SUBJECT: Revised Preliminary Subdivision Plan Approval for the single-family residential Open Space Conservation Subdivision known as the Reserve at River Oaks, Phases I-V.

PC Case No: 2018-5349

RE: The Reserve at River Oaks Subdivision – Phase 4
Revised Exhibit and Engineers Estimate

Date: December 3, 2018
To: Kris McMaster, City Planner
C: Greg Hannan, Director of Community Development
From: Bradley Kosco PE., PS., City Engineer
Re: **Reserve at River Oaks Phase 4 – Revised Cost Estimates for Proposed Waterline and Path Improvements**

**WATERMAIN AND PATH EXTENSION PROJECT FROM
RIVER OAKS PHASE 4 TO PRESTIGE SUBDIVISION PHASE 5
HUDSON, OHIO
DGB 4272-3W**
OCTOBER 31, 2018 **REVISED NOVEMBER 20, 2018**

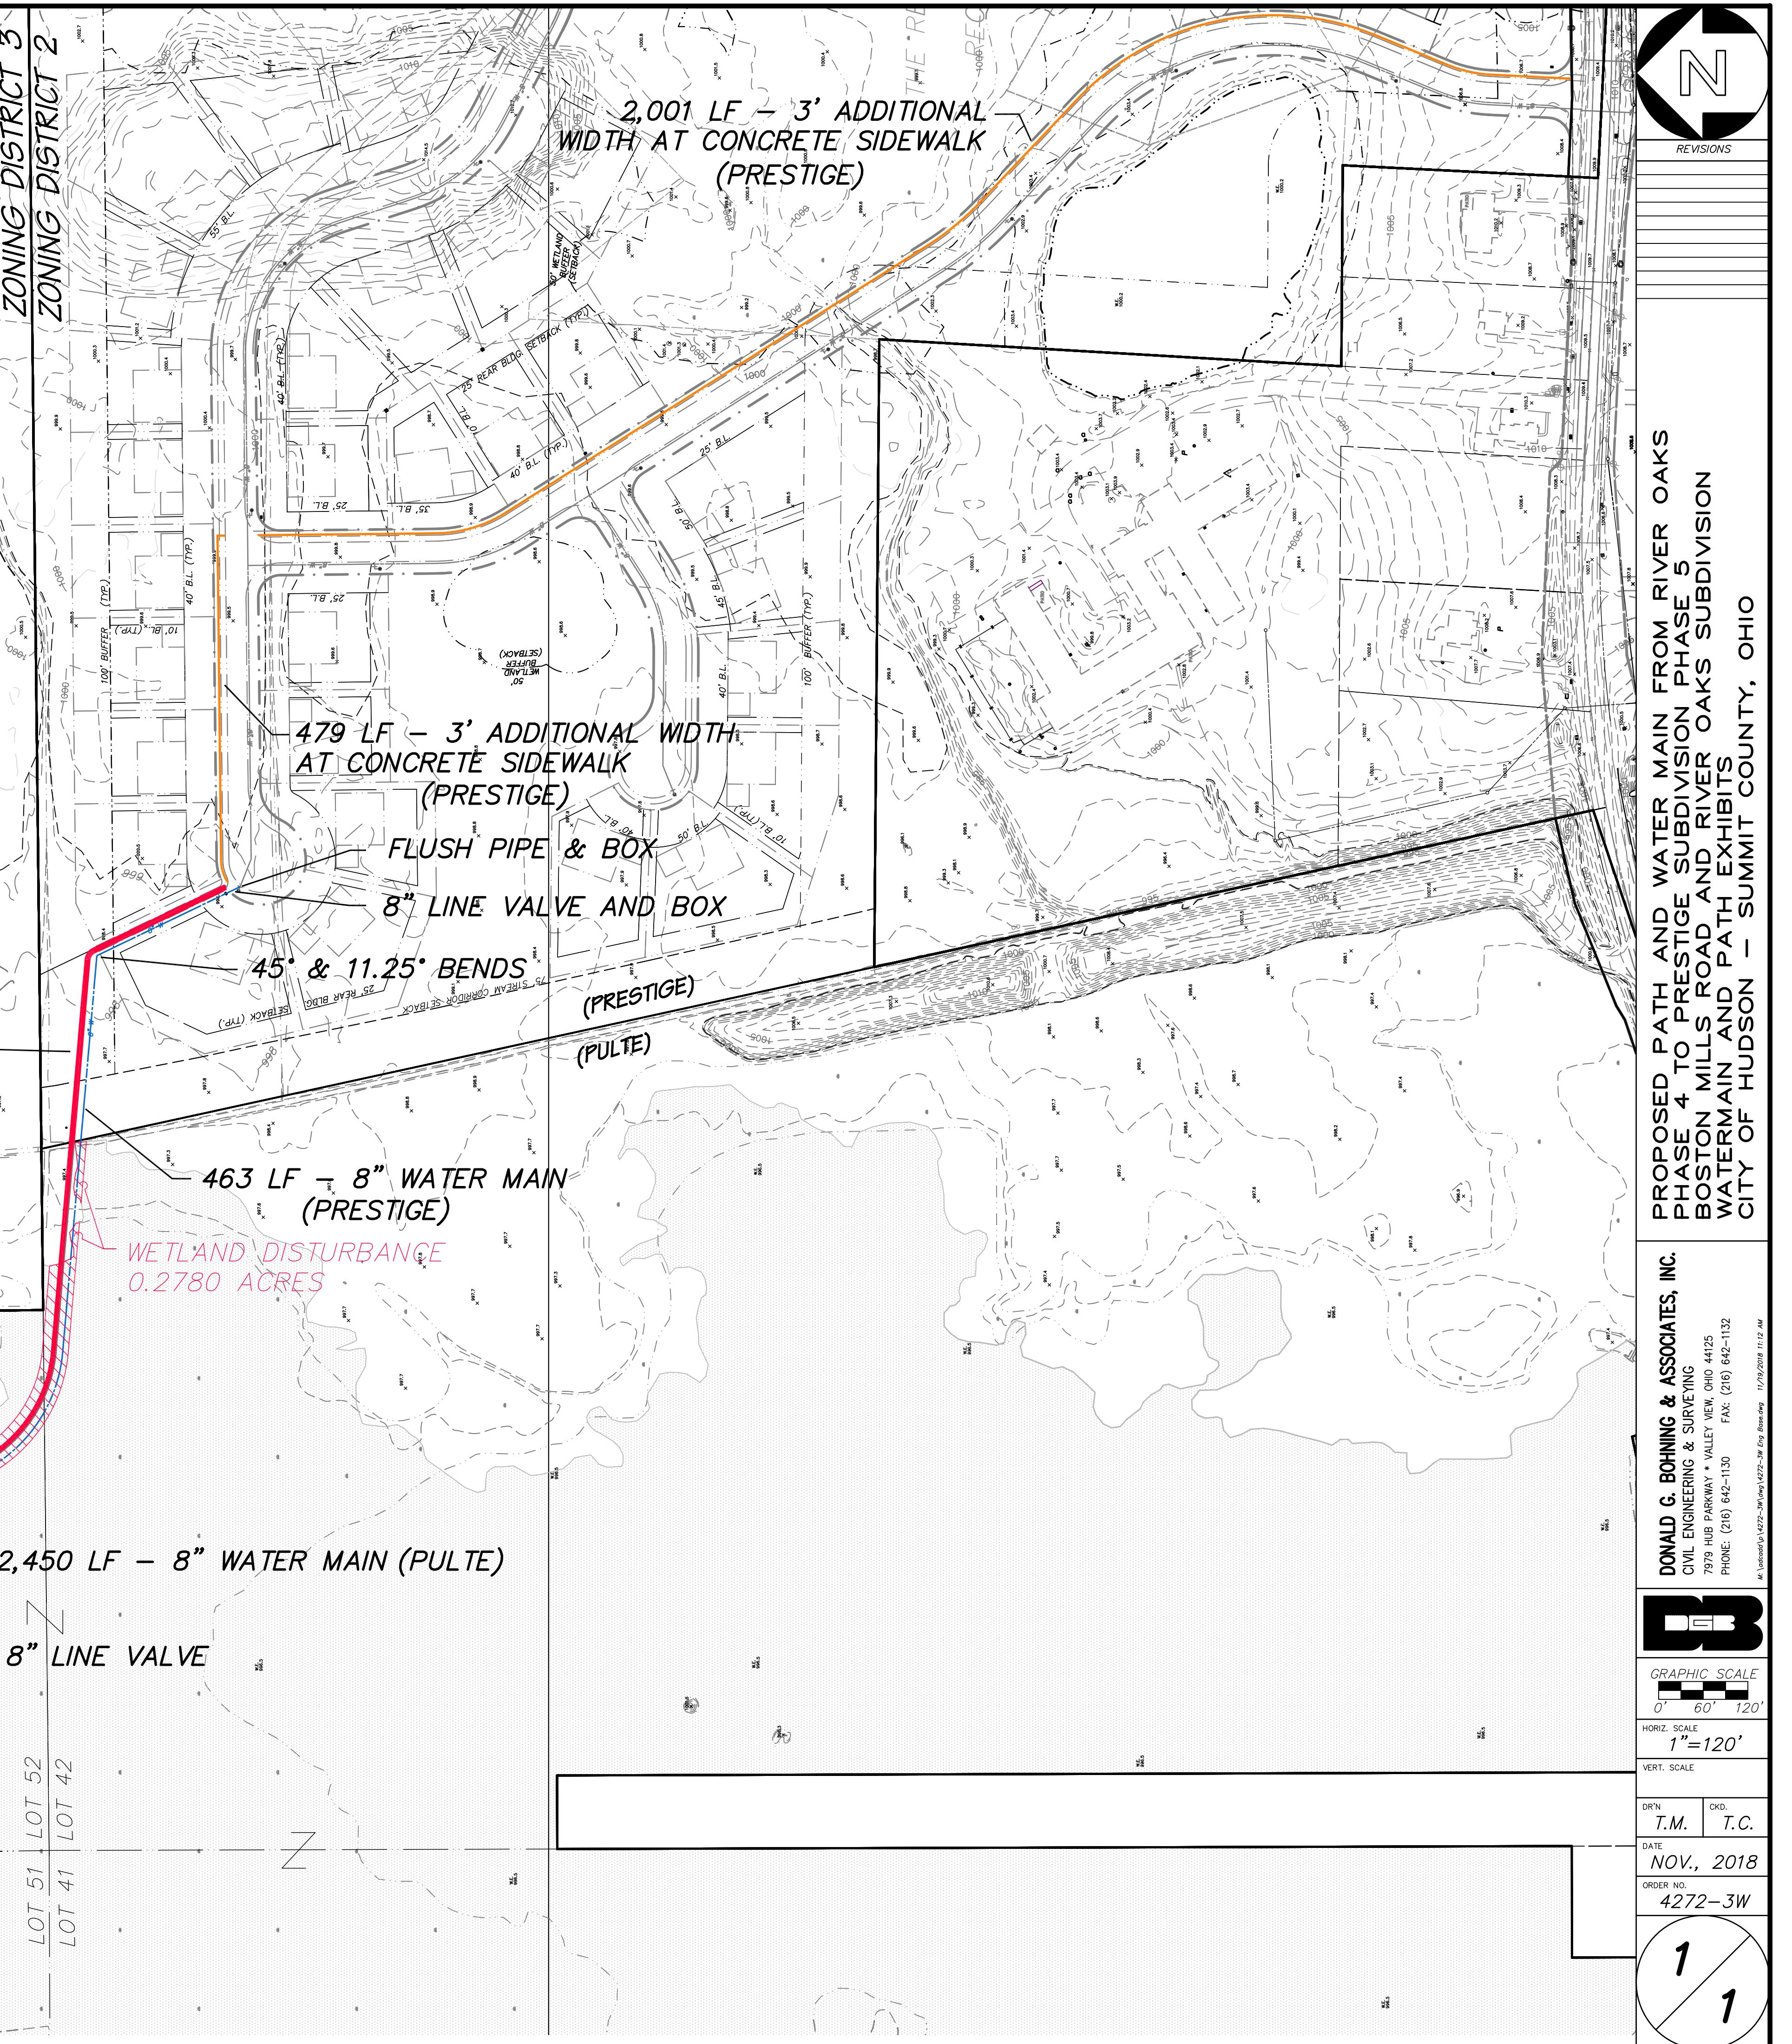
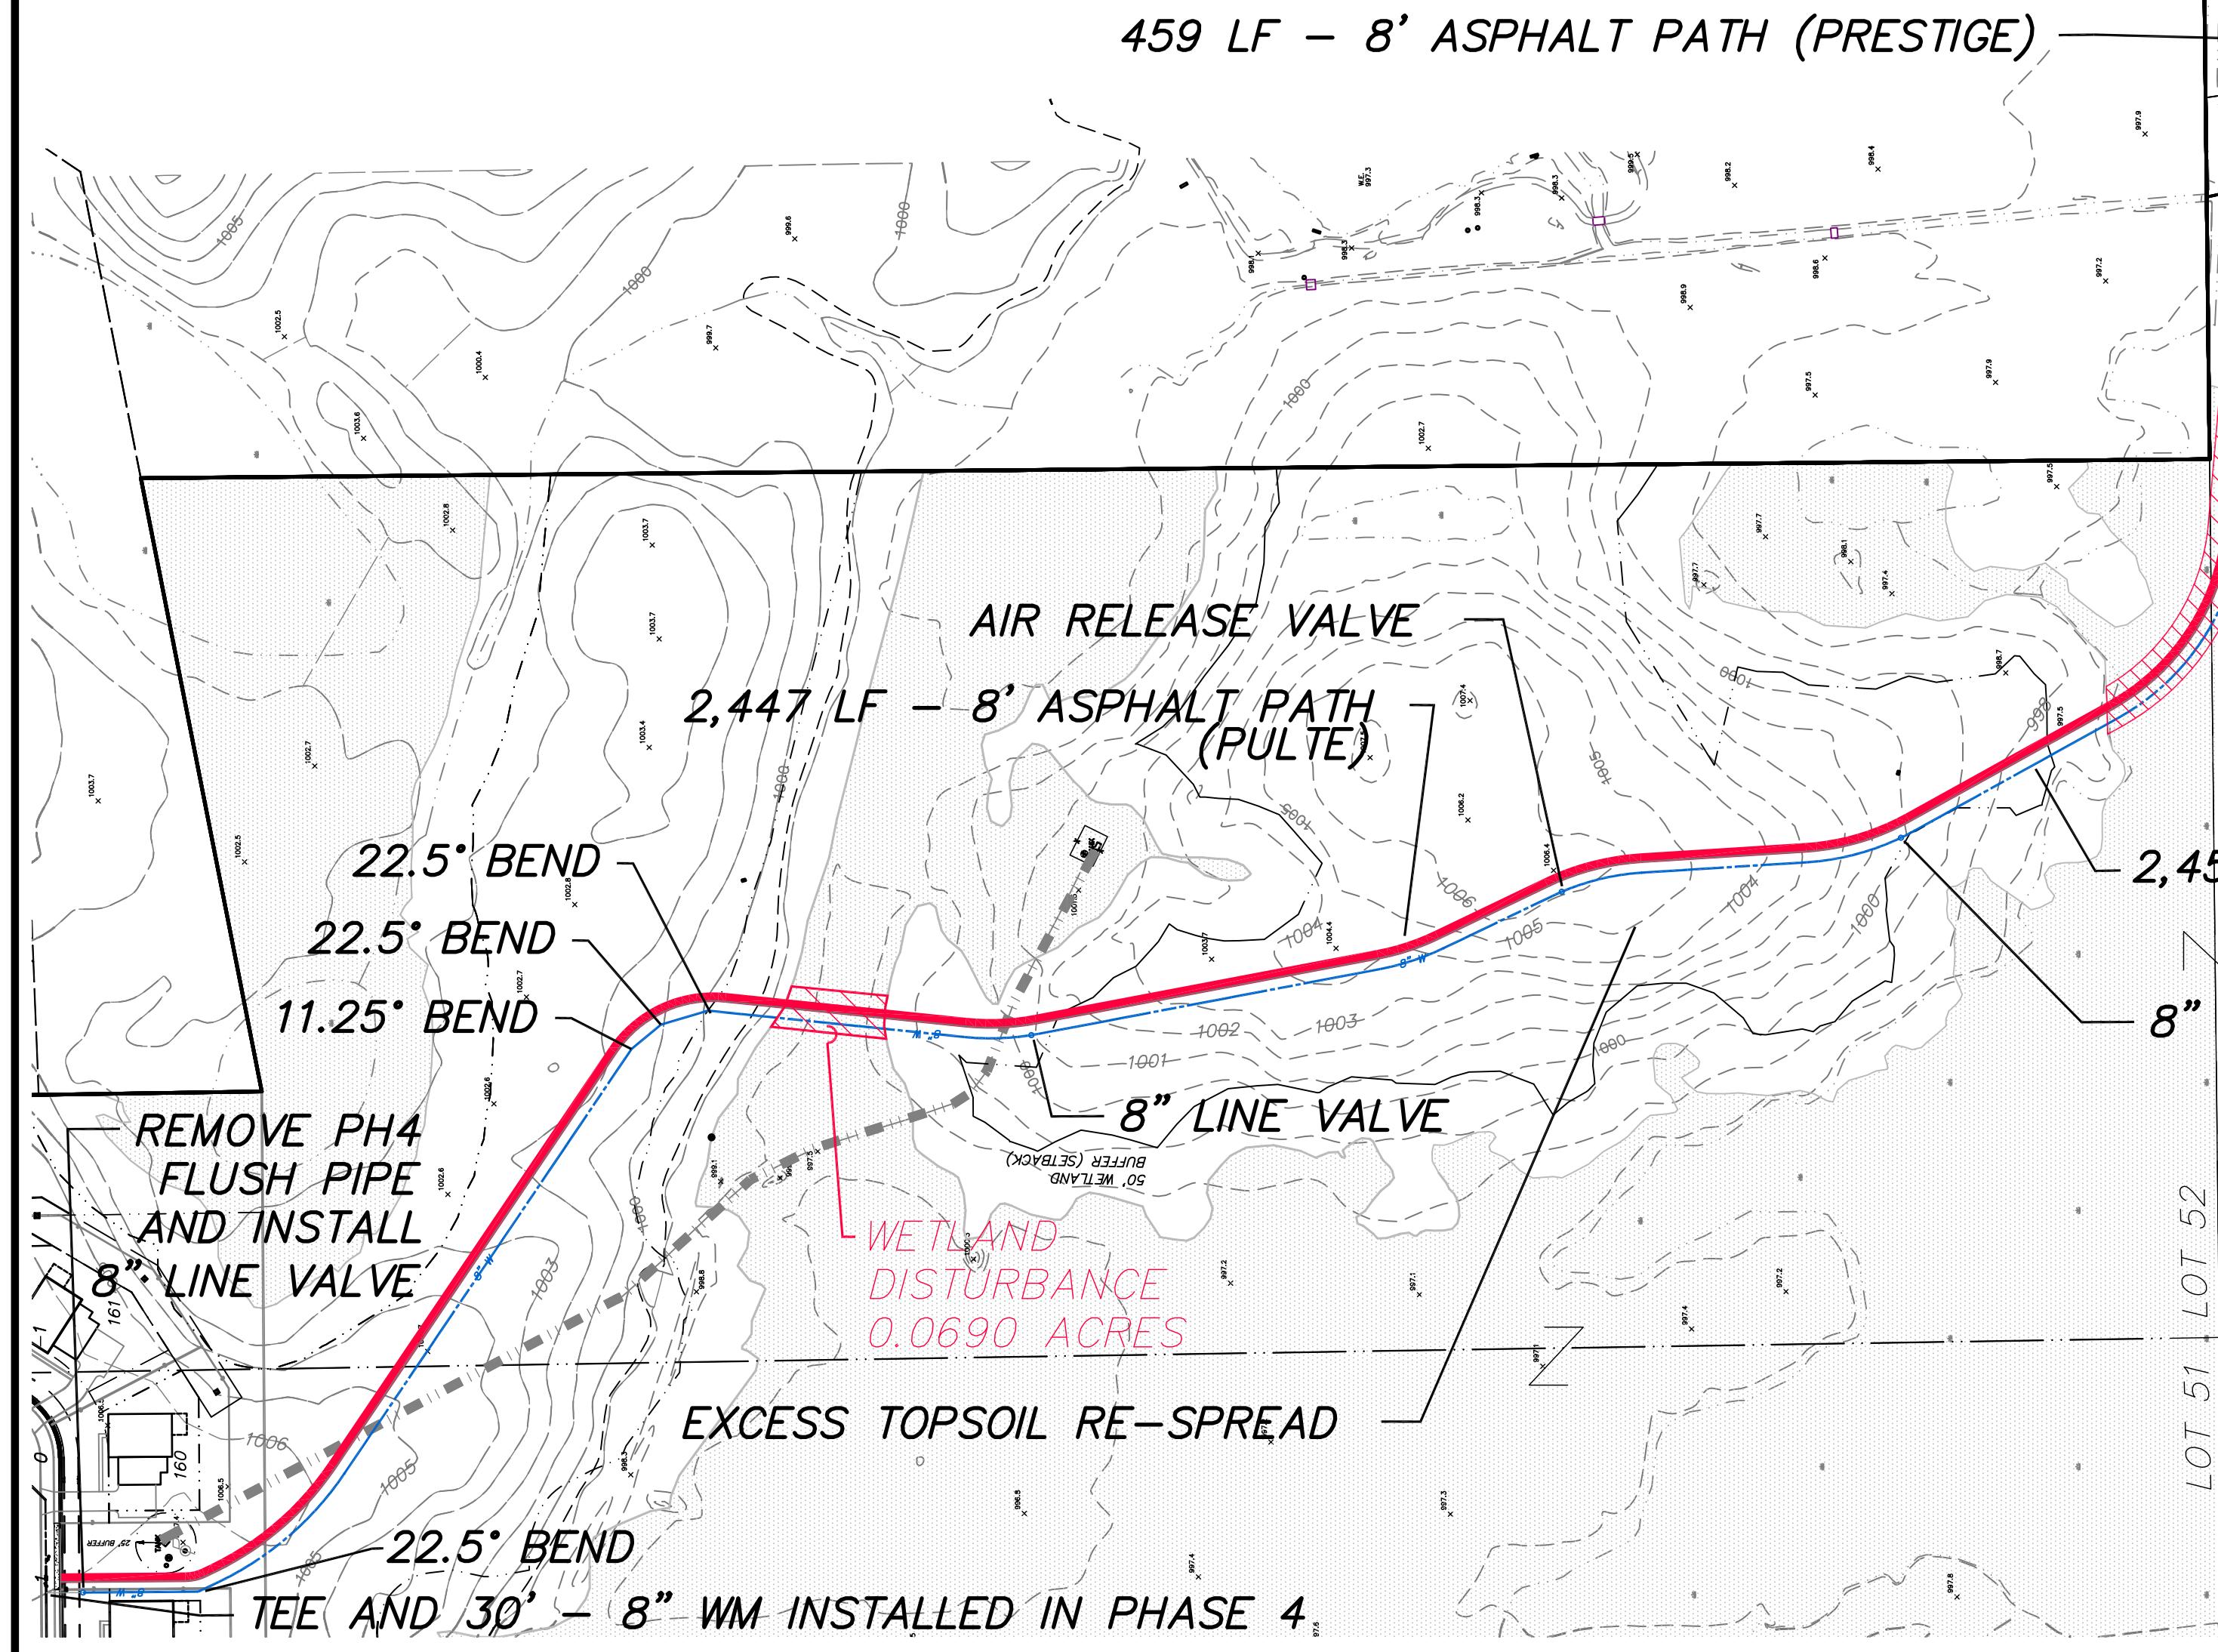
1. Pavement – The City's typical pavement build up (Drawing 7.1.5) for walking paths is attached and will need incorporated into the cost estimate.

2. Waterwork – Verify any high spots on waterline alignment (no labels on contours). Blow-off assemblies will be required at high spots.

3. Waterwork – Mainline water valves are required a min. 500 foot intervals (10 State Standards). At 2,900 LF of waterline, a min. of six main valves would have been required for the connection between properties.

4. Waterwork – Is Dewatering accounted for anywhere?

5. Miscellaneous – Add an inflation cost increase of 3.9% (ODOT projected rate) for 1 year (i.e. Construction Cost Estimate = $\$580,000 \times 0.039 \times 1 = \$22,500+1$). I suggest one year because Pulte would have likely installed some/most of infrastructure within next 12 months).
Per the provided ODOT documentation, a 4.8 percent inflation rate was applied to the total engineer's estimate. For an estimate total of \$596,957, 4.8 percent would be \$28,653.94, for a total engineer's estimate of \$625,610.94.

6. Notes – Please forward a copy of the “Davey Estimate (2)” outlining the terms of mapping, reporting, permitting for a cost of \$68,500.
An updated copy of the cost breakdown from Davey has been included, which has an estimated cost of \$96,700.

1. The plan should have included cost to jack and bore casing pipe to avoid wetland disturbance for future maintenance (similar casing pipe install planned for water connection between Hudson Crossing Parkway and River Oaks 3). Please comment.
The engineer's estimate and exhibit assumed the watermain would be open-cut per the wetland permitting. The Davey estimate was updated for category 3 wetlands and the cost increased from \$68,500 to \$96,700.

The path detail on the exhibit was updated per the City's pavement build up and the engineer's estimate was revised.

Contour labels were added to the exhibit. One Air release valve is now shown and has been added to the engineer's estimate.

Section 8.3 of 10 State Standards lists 800 foot intervals in non-commercial districts and also states "where widely scattered customers and where future development is not expected, the valve spacing should not exceed one mile." Since there wouldn't be any house connections on the circulation main from River Oaks Phase 4 to Phase 5, the main would fall under the minimum spacing criteria of one mile. Two additional valves were added to the plan for maintenance convenience to increase the total number of valves from 2 to 4.

The engineer's estimate assumed dewatering was included in the price of \$63/LF.
